BEFORE THE MISSISSIPPI PUBLIC SERVICE COMMISSION

2017-UA-79

IN RE: SUPPLEMENTAL PETITION OF
SOUTHERN SPIRIT TRANSMISSION LLC
FOR CERTIFICATE OF PUBLIC
CONVENIENCE AND NECESSITY FOR
THE PROPOSED SOUTHERN SPIRIT
TRANSMISSION PROJECT

DIRECT TESTIMONY

FIGURE 1

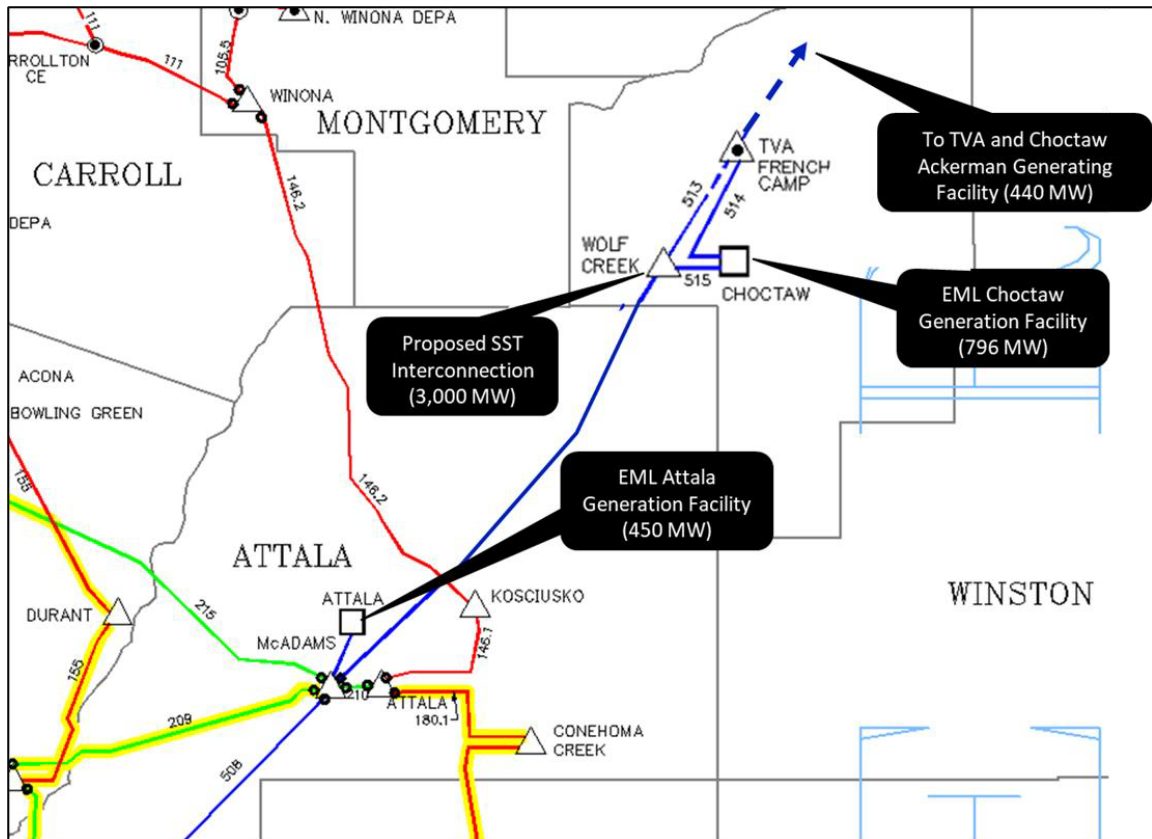
Figure 1 shows that the location of the proposed interconnection is near the border between EML's transmission system, which is part of MISO, and TVA's transmission system. Figure 1 also shows that the location of the proposed interconnection is electrically similar to the location of EML's Choctaw and Attala generating facilities and the Ackerman generating facility interconnected to the TVA system, by which I mean that SST will interconnect to the same 500 kV line as these resources (1,686 MW). The capacity of this line is insufficient (because it was not designed or intended) to accommodate simultaneous injections from SST and these generating facilities – even if injections from

1 SST are limited to 1,500 MW instead of 3,000 MW and without consideration of flows
2 from any other generators.

3 The inability of this 500 kV line to accommodate the output of these specific
4 resources demonstrates the obvious need for AC upgrades to address overloading of the
5 500 kV line to which SST is proposing to interconnect. In addition to addressing
6 overloading on this 500 kV line, additional AC upgrades will likely be necessary to ensure
7 that power can be distributed further “downstream” of the interconnection point because
8 the existing system was not designed to accommodate an incremental 3,000 MW injection
9 (approximately doubling EML’s current generating capacity) – or even a 1,500 MW
10 injection – at this location. AC upgrades – potentially including several large ones – will
11 very likely be required to reliably accommodate injections from the project. However,
12 MISO has not yet identified the upgrades that will be necessary to reliably accommodate
13 injections from SST and SST has provided nothing to indicate it has attempted to identify
